# **REGIONAL REVIEW FINDING**

**RE:** Development of Regional Impact (DRI) Review

Name of Proposal:Hawks Ridge DRI 3955Submitting Local Government:City of South FultonDate Opened:May 10, 2023Date Closed:June 1, 2023

**Description**: A DRI Review of a proposal to construct 522 single-family homes on a 360-acre wooded site traversed by several streams off of Cascade Palmetto Highway and Butner Road in the City of South Fulton.

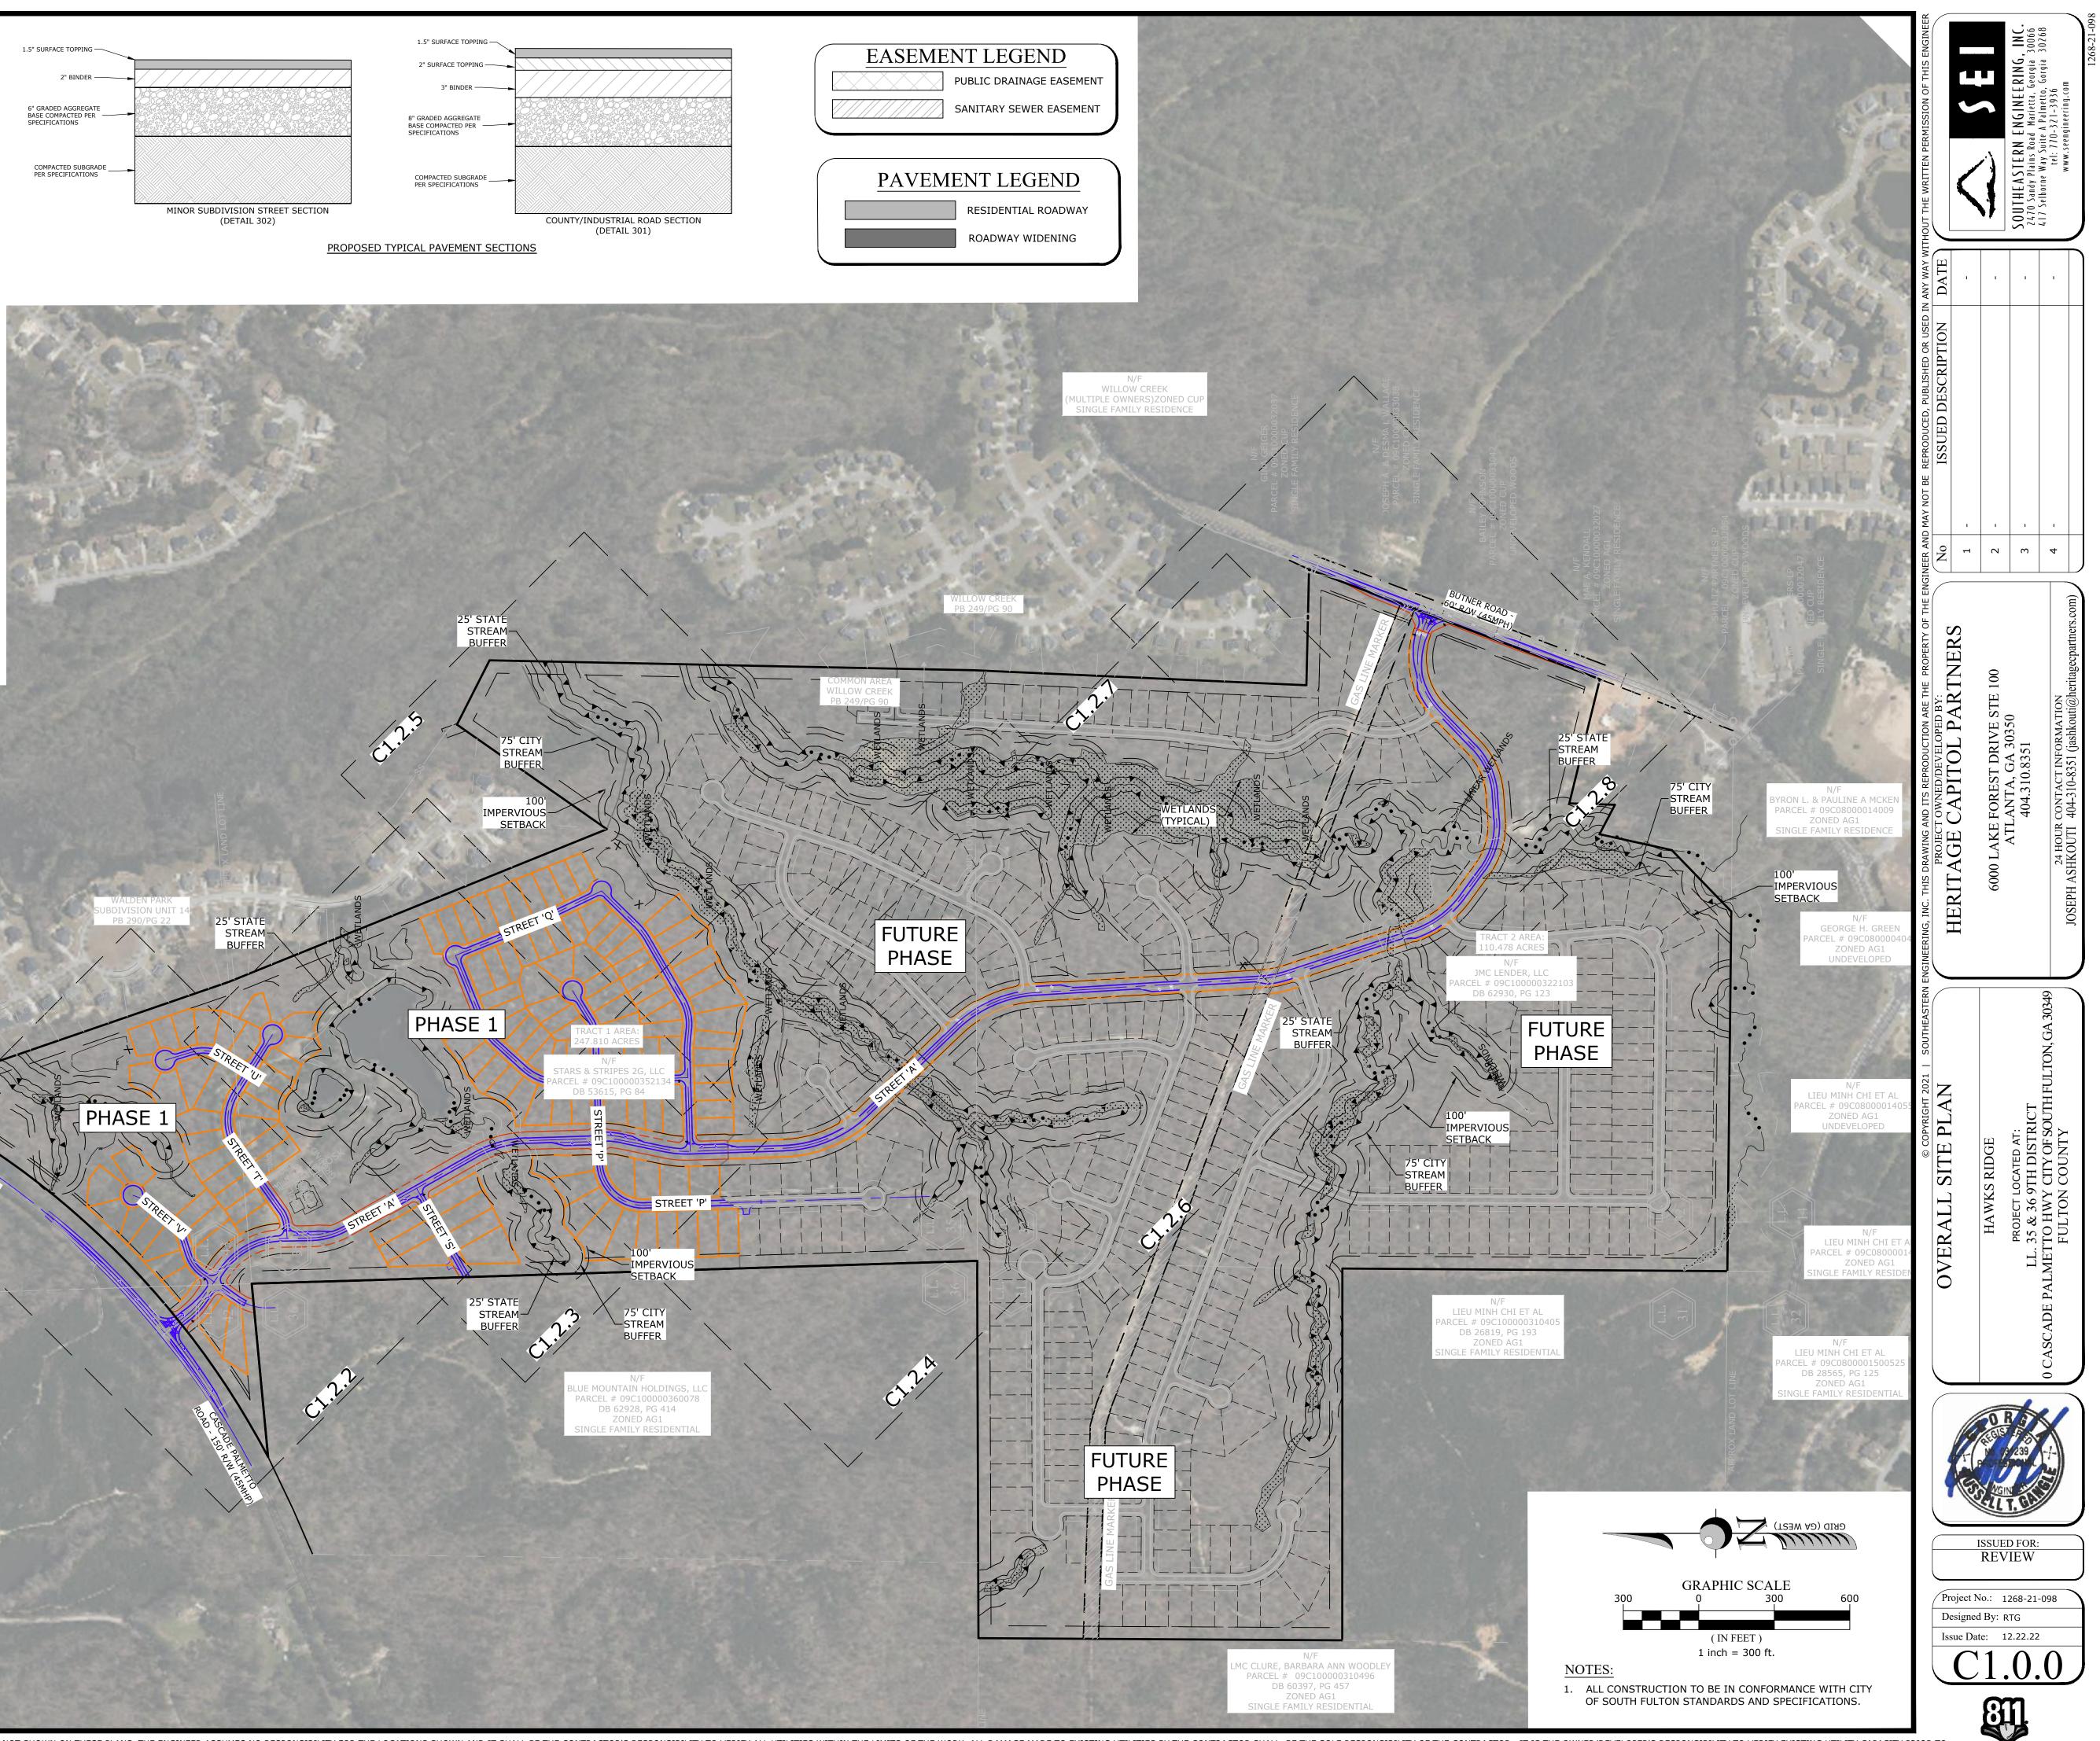
The project utilizes a winding street pattern with numerous cul-de-sacs in part due to the nature of the site. Adjustment of this pattern to provide better automobile and pedestrian connectivity would be supportive of regional transportation and sustainability policies.

The project utilizes a winding street pattern with numerous cul-de-sacs in part due to the nature of the site. Adjustment of this pattern to provide better automobile and pedestrian connectivity would be supportive of regional transportation and sustainability policies.

Both the project site plan and the USGS coverage for the project area show three unnamed tributaries to Deep Creek crossing the property from roughly southwest to northeast. The submitted site plan also shows several branches off these three streams, as well as a fourth tributary to Deep Creek at the northern end of the property and one stream in the northwest corner of the Future Phase area, flowing to the northwest off the property. The site plan shows The 100-foot Impervious setback and 75-foot undisturbed buffer required under the City of South Fulton's Unified Stream Buffer Protection ordinance, as well as the State 25-foot Erosion and Sedimentation Buffer. The only intrusions shown on the submitted site plan are transportation crossings, which are allowed under the City ordinance. The rear property line of some of the proposed lots extend into the 100-foot setback. Future activity in these areas may require variances from the City. Any unmapped streams on the property may also be subject to the requirements of the City Stream Buffer Ordinances and any other waters of the State on the property will be subject to the 25-foot state Erosion and Sedimentation Act buffers.

The proposed retention of 40% of the site's 360 total acres supportive of regional environmental goals. Retention of additional natural wooded areas would be in keeping with regional policies regarding carbon sequestration and heat island mitigation. There may be potential opportunities for linking these fragmented undeveloped areas with adjacent undeveloped or protected areas to ensure their maintenance and potential use for recreation or habitat preservation.

Based on preliminary review of the proposed new roadway intersection with the state route, there is a likely chance that the new intersection will have inadequate sight distance based on the current roadway topography. GDOT will ask that sight all access points on the state route be certified for sight distance. If minimum sight distance cannot be achieved then the new intersection will be designed to remove the movements effected by the inadequate sight distance.
